Applicant : Handique, *et al.*
Serial No. : 10/567,002
Filed : January 31, 2006
Page : 23 of 34

AMENDMENTS TO THE DRAWINGS

Marked-up versions of FIGs. 2, 6a, 6b, 6c, 6d, and 9a showing changes in red, follow this page; replacement sheets are positioned after the last page of the "Remarks" section of this amendment.

Applicant's Amendment and Reply to Office Action dated January 30, 2008
Annotated Sheet Showing Changes

FIG. 2

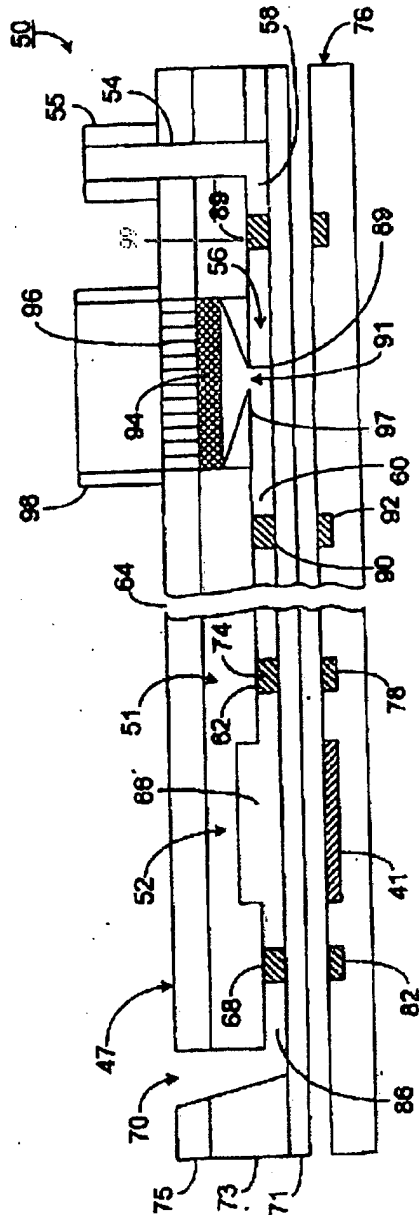
FIG. 2 has been amended to correct the reference numeral 89 to 85. The positioning of such new or revised reference numerals is based on other drawings as filed and the accompanying description found in the specification as filed.

FIG. 6A

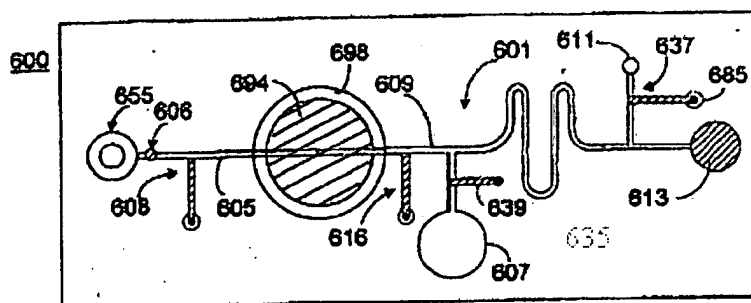
FIGs. 6a, 6b and 6c have been amended to replace the reference numerals 698, 697, and 697 by, respectively, 699, 696, and 696. The positioning of such new or revised reference numerals is based on other drawings as filed and the accompanying description found in the specification as filed.
